GPU Nuclear Corporation

Subject: Oyster Creek Nuclear Generating Station (OCNGS)
Full Term Operating License (FTOL) Conversion
Environmental Review

Enclosed are the responses to the questions contained in your letter of March 7, 1984. A number of the responses provide projected dates by which GPUN presently anticipates completing certain activities. The dates presented represent only our present projection based upon the information available and are not meant to be construed as final commitment dates for completing the various activities. Should you or your staff have any additional questions or require any additional information, please do not hesitate to contact me or Mr. Douglas R. Moore of our Environmental Licensing staff at (609) 971-4630.

Figure 2-A

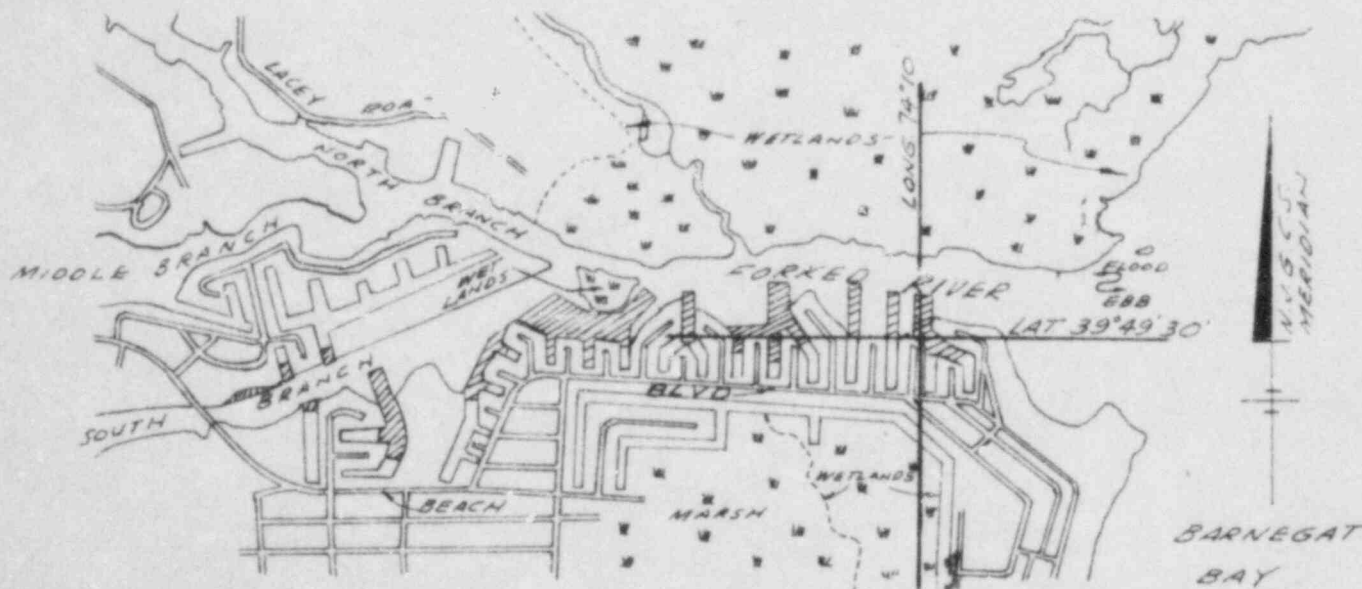
Refer to attachment of letter dated March 21, 1983, to D. M. Crutchfield from P. B. Fiedler. Item 3e response states that Oyster Creek was dredged in 1978-79. When is the next scheduled dredging? Item 3e further states that Forked River was to be dredged in 1983-84. Has this work been completed? If not, give percent completion. Also include on an aerial photograph or map the location of the area where spoil from both the 1978-79 and 1983-84 dredging was and/or is to be deposited, the total acres over which the spoil will be deposited and detailed plans to revegetate the areas. Provide copies of any environmental review done in conjunction with the dredging.

A map showing the location of the spoil disposal site for the 1984-85 Forked River dredging project is attached (Figure 2-A, & 2-B). The same 22 acre site was used for the 1978-79 Oyster Creek dredging project.

Figure 3

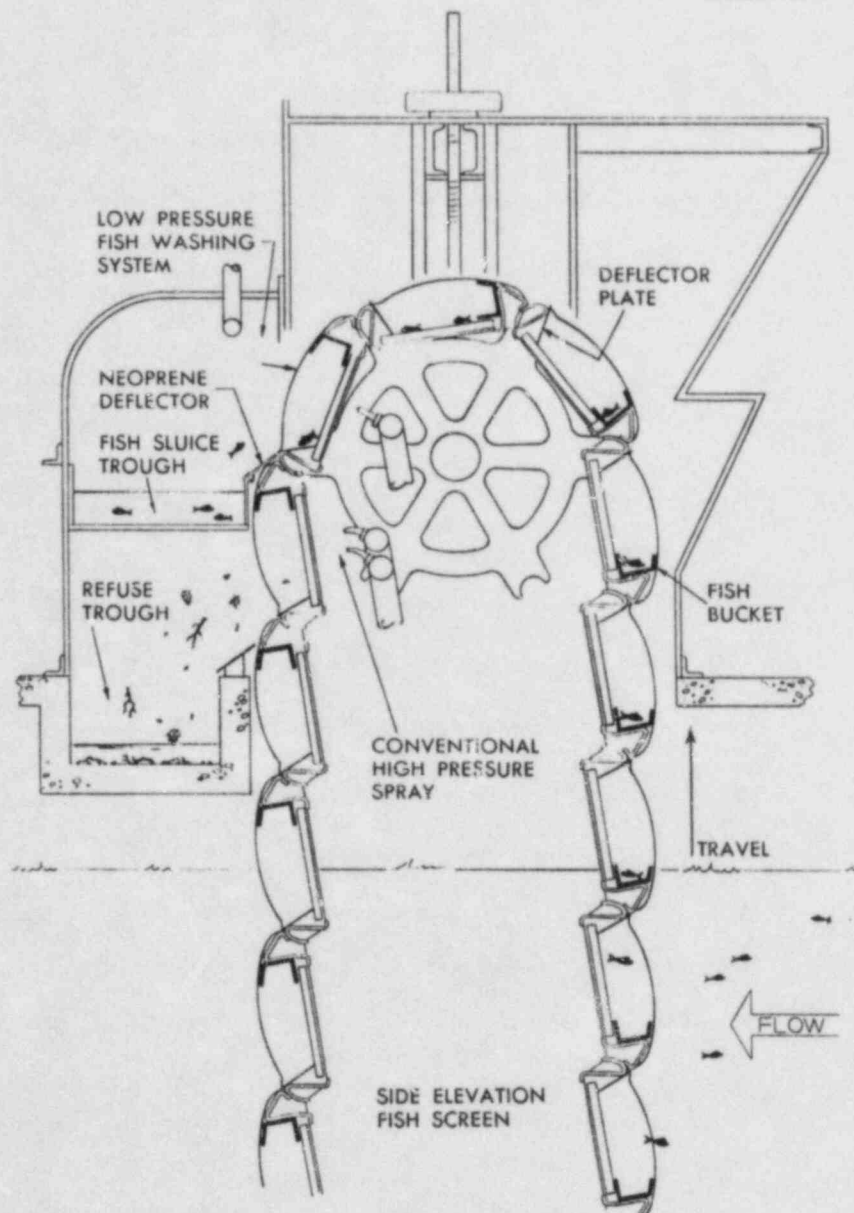
- (b) Provide, also, the design (diagrammatic) and operational characteristics of the new intake traveling screen-fish handling system.

The six (6) loops of traveling water screens serve to screen out debris and marine life. This function is performed by a loop of screen panels propelled over a pair of head sprockets. The loop is anchored by foot sprockets which rotate freely on the fixed footshaft. The head sprockets are keyed in pairs to the head shaft and driven by an outboard driven sprocket. A conceptual sketch of a traveling screen is presented in Figure 3.
